SUBJECT: COOPER NUCLEAR STATION - AMENDMENT NO. 155 TO FACILITY
OPERATING LICENSE NO. DPR-46 (TAC NO. M84240)

Amendment No. 155
License No. DPR-46

SAFETY EVALUATION BY THE OFFICE OF NUCLEAR REACTOR REGULATION
RELATED TO AMENDMENT NO. 155 TO FACILITY OPERATING LICENSE NO. DPR-46
NEBRASKA PUBLIC POWER DISTRICT
COOPER NUCLEAR STATION
DOCKET NO. 50-298

Figure 3.6.1.a Minimum Temperature for Non-Nuclear Heatup or Core Cooldown Following Nuclear Shutdown

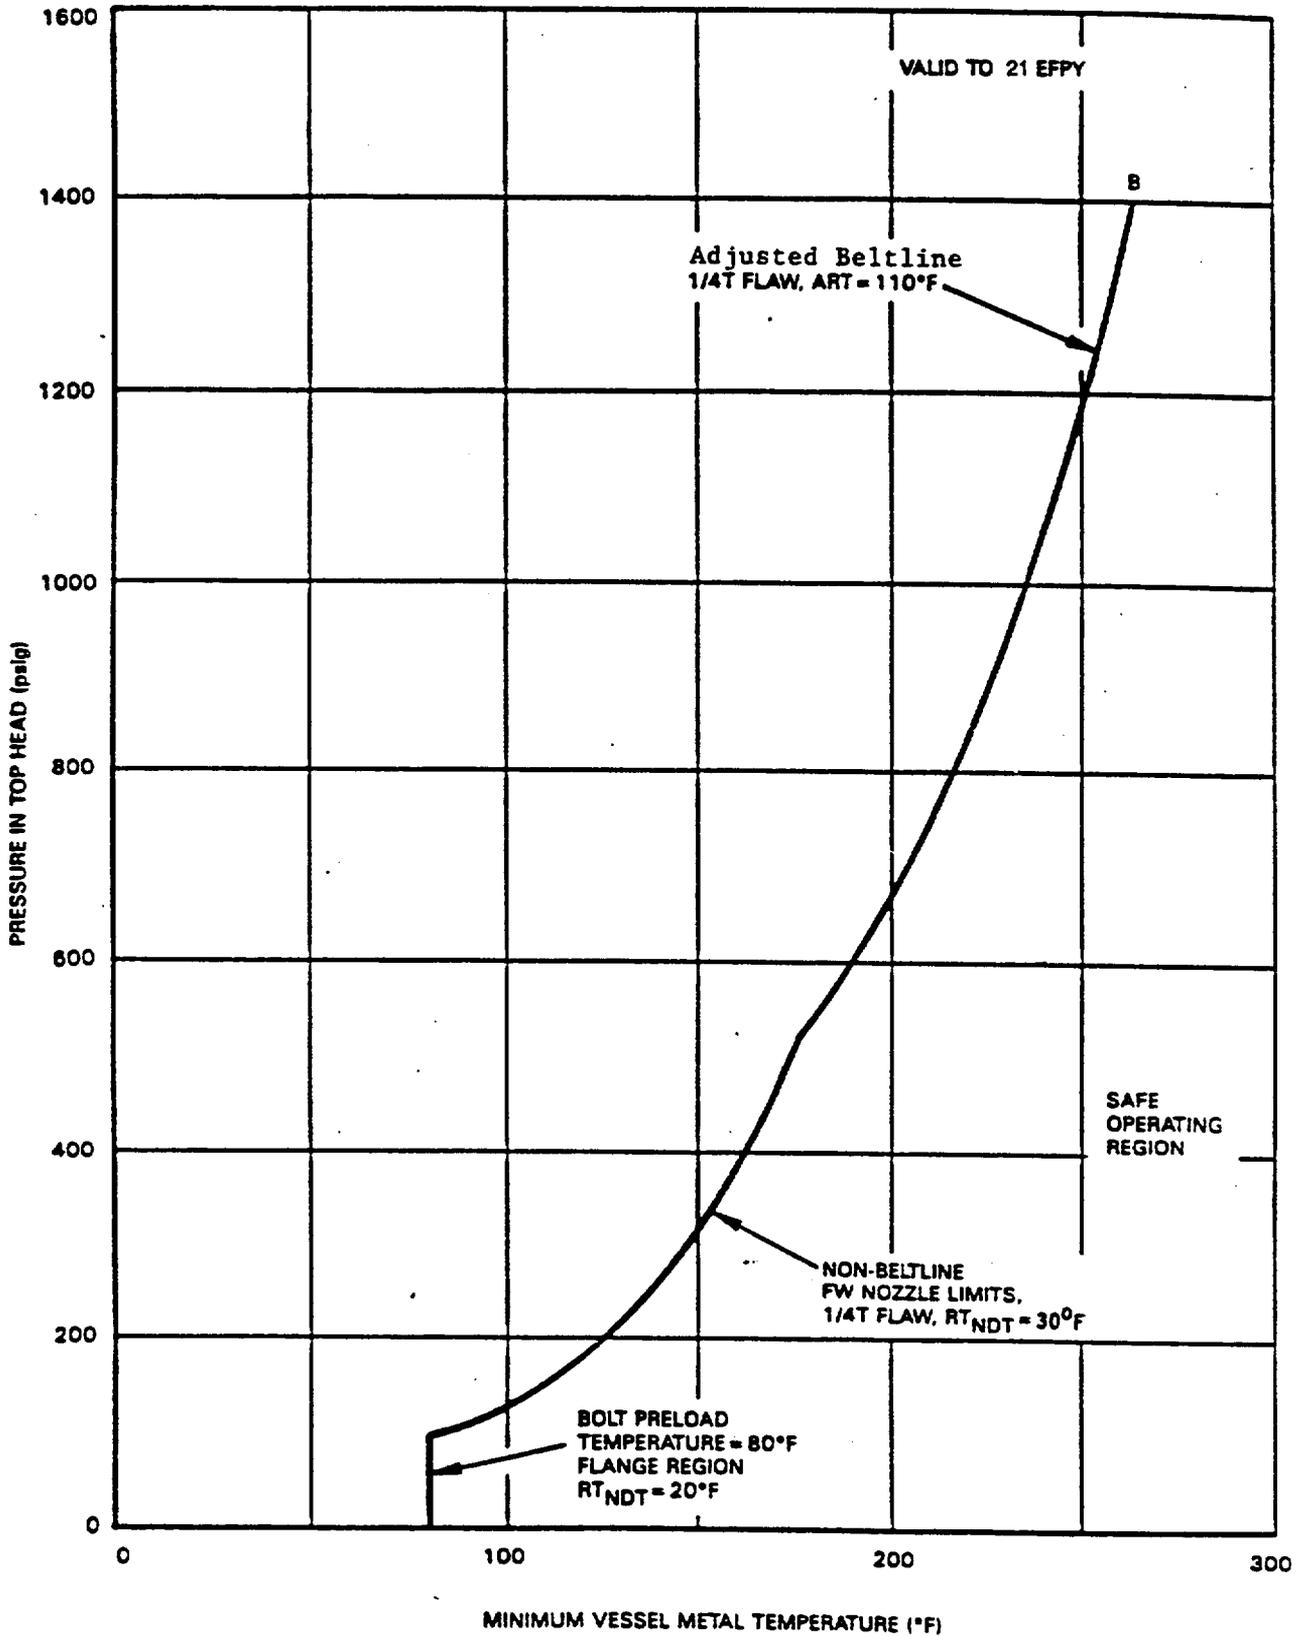
2. During operation where the core is critical or during heatup by nonnuclear means or cooldown following shutdown, the reactor vessel metal and fluid temperatures shall be at or above the temperatures shown on the limiting curves of Figures 3.6.1.a or 3.6.1.b. This specification applies when the reactor vessel head is tensioned.

The licensee proposed the following: 1) revise pressure/temperature (P/T) limits for heatup, cooldown, and criticality to 21 effective full-power years (EFPY), 2) revise P/T limits for hydrostatic or leak test to 13, 18, and 21 EFPY, and 3) relocate the capsule withdrawal schedule for the surveillance of reactor vessel materials to the Updated Safety Analysis Report (USAR).

Substituting the staff's ARTs into equations in SRP 5.3.2, the staff verified that the proposed P/T limits for heatup, cooldown, criticality, and hydrotest meet the beltline material requirements in Appendix G of 10 CFR Part 50.

The staff concludes that the proposed P/T limits for heatup, cooldown, and criticality are acceptable through 21 EFPY and the proposed limits for hydrotest or leak test are acceptable for 13, 18, and 21 EFPY because they all conform to the requirements of Appendix G of 10 CFR Part 50 and Generic Letter 88-11. Hence, the proposed P/T limits may be incorporated into the Cooper Technical Specifications.

Figure 3.6.2 Minimum Temperature for Pressure Tests Such as Required by Section XI

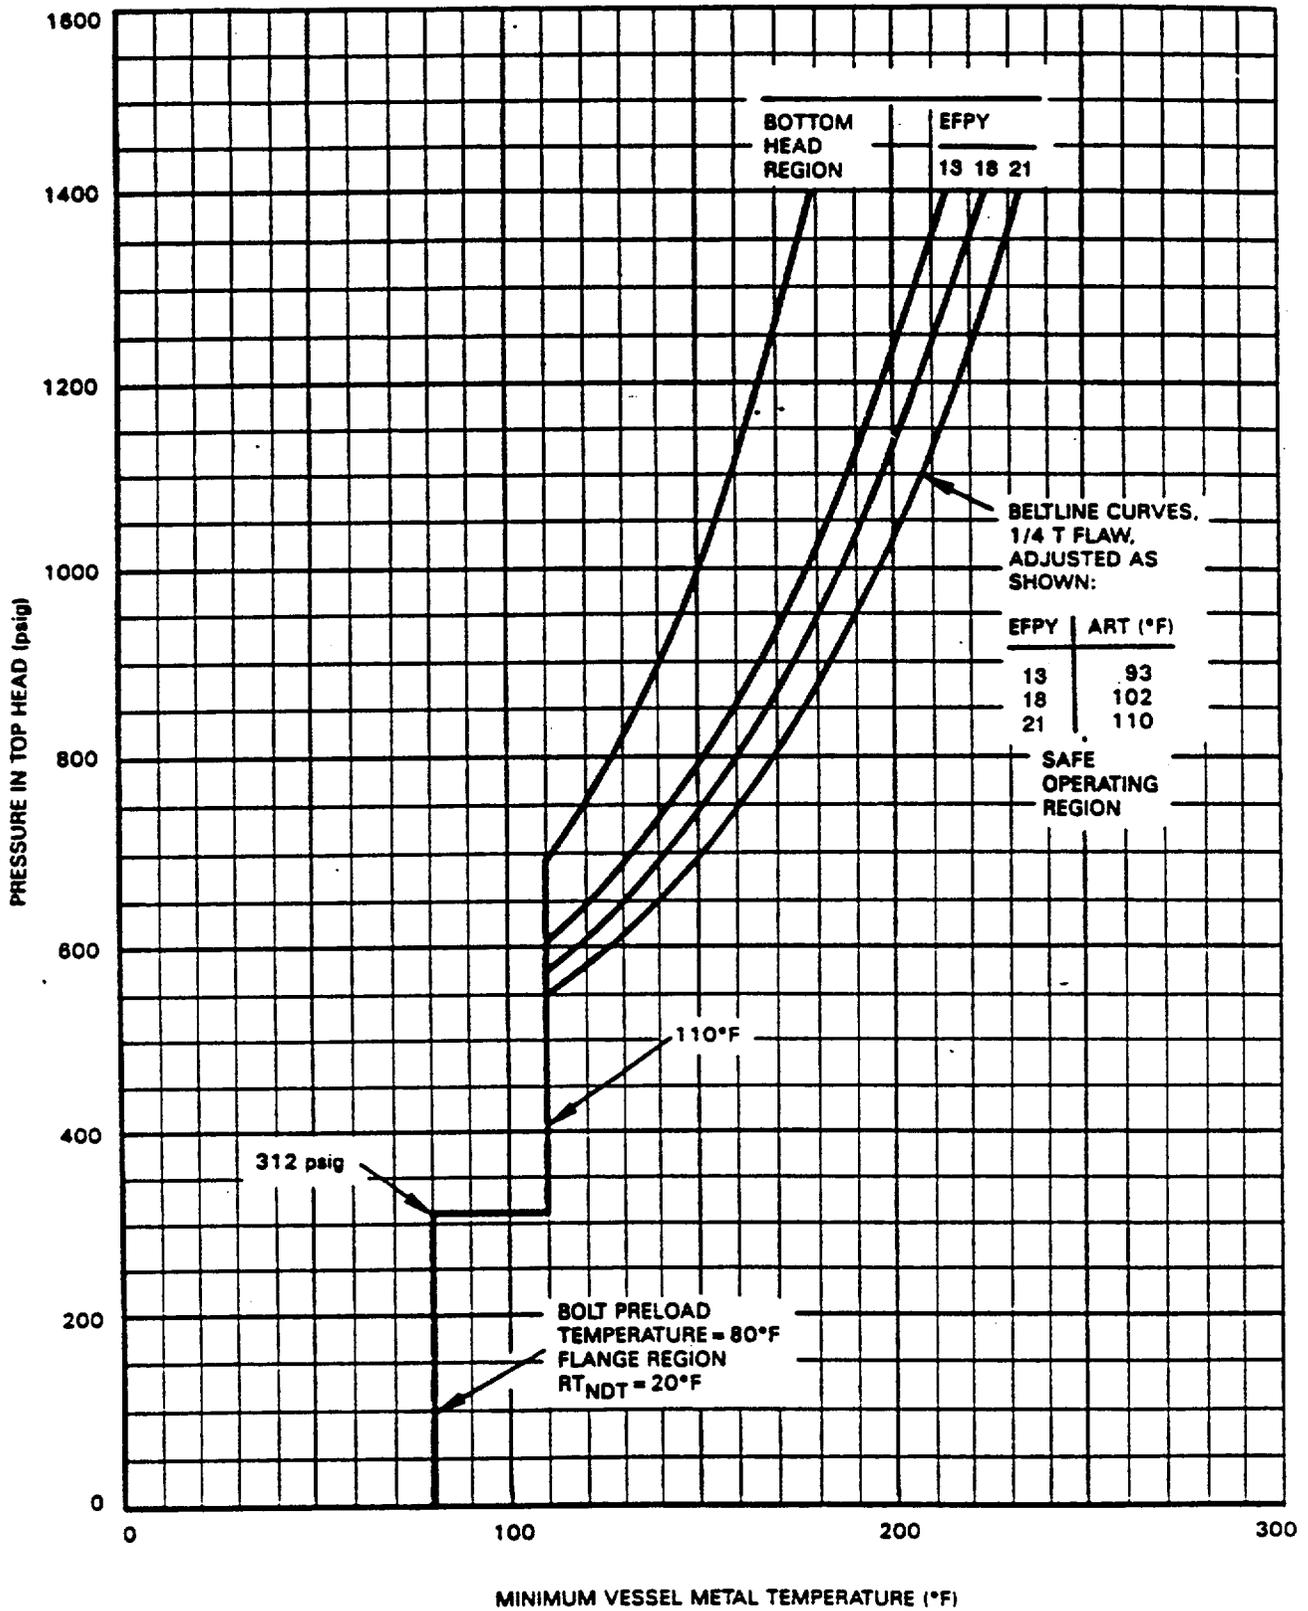
3. The reactor vessel metal temperatures for the bottom head region and beltline region shall be at or above the temperatures shown on the limiting curves of Figure 3.6.2 during inservice hydrostatic or leak testing. The Adjusted Reference Temperature (ART) for the beltline region must be determined from the appropriate beltline curve (13, 18, or 21 EFPY) depending on the current accumulated number of effective full power years (EFPY).
